UNITED STATES PATENT AND TRADEMARK OFFICE

10/718,184

Jeffrey R. Lehtinen

Office Action Summary

FIG. 7B

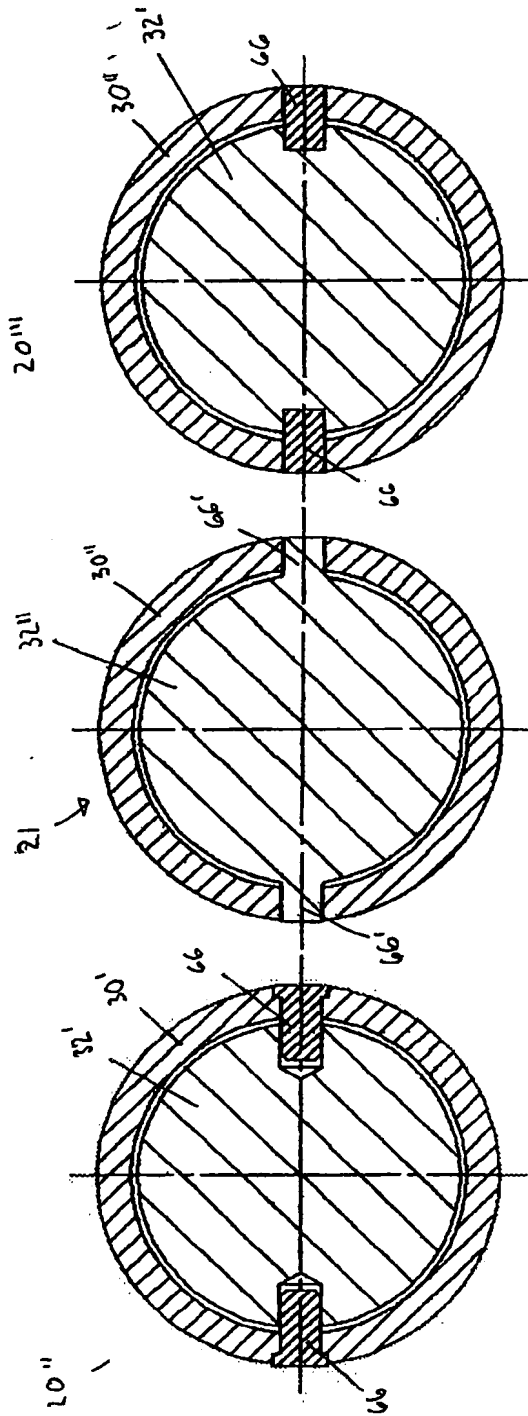
1. The drawings were received on 05/14/2007. These drawings are objected as Fig. 7B illustrates new matter. These drawings have not been entered.

2. The amendment filed 05/14/2007 is objected to under 35 U.S.C. 132(a) because it introduces new matter into the disclosure. 35 U.S.C. 132(a) states that no amendment shall introduce new matter into the disclosure of the invention. The added material which is not supported by the original disclosure is as follows:

"Specifically, the construction of nozzle 20", shown in Fig. 7A, represents a transverse, schematic, cross sectional view of the Fig. 7 construction, taken through spray tip 32' at the center line of pivot pins 66. In the Fig. 7C construction of nozzle assembly 20", even though opposed pin members 66 are similarly outwardly directed as in Fig. 7A, pin members 66 are fixedly received in spray tip 32', thereby shifting the rotational interface to shroud 30", while, in Fig. 7A, the rotational interface remains with nozzle tip 32'. *In the Fig. 7B construction, in order to facilitate the assembly of spray tip 32", shroud 30' of Fig. 7A may be split into two cylindrical shell portions 30" (only one being shown) [there is no support for this – the previous paragraph only mentions two semi-cylindrical shells and Fig. 6 appears to show only a cutaway near the pin 66 rather than two cylindrical shells] abutting at pin members 66, each shell portion having opposed cylindrical cutouts in order to accommodate pin members 66. Upon completion of the assembly, the split may be closed via a rotational weld [there is no support for this]. Finally, in the Fig. 7B nozzle construction 21, pin members 66' are preferably **integral** [not supported – the pin*

is only shown as a separate element previously] *with spray tip 32", thereby again shifting the rotational interface to shroud 30" which, in order to permit assembly is also comprised of two adjoining cylindrical shell portions 30" in a manner similar to that described relative to Fig. 7C.* Thus, the Fig. 7B and 7C constructions are essentially the reverse of the Fig. 7A nozzle construction."

Applicant is required to cancel the new matter in the reply to this Office Action.

ENTRY
NOT APPROVED
